### Customer States the Intermittent Wiper Function Operates Erratic on Vehicles With Rain Sensor

92 06 06 Oct. 20, 2006 2013173

Model(s)	Year	Eng. Code	Trans. Code	VIN Range From	VIN Range To
Touareg	2007	All	All	7L_7D000001	7L_7D034999

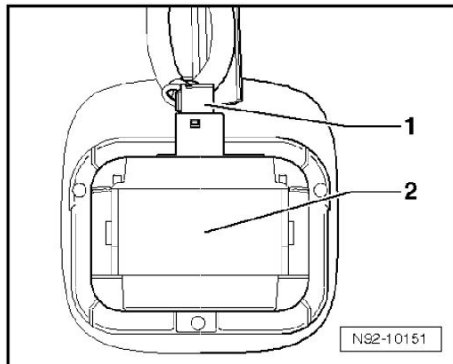
- Identify rain sensor 1K095559R/T (there is only one set of diodes in the center of the part that contacts the windshield).

The improved rain sensor is identifiable by the white optical receptors - arrows-, or if view closely, the stacked diamond shape through the middle of the sensor.

- Install improved rain sensor Part No: 1K0955559AB.
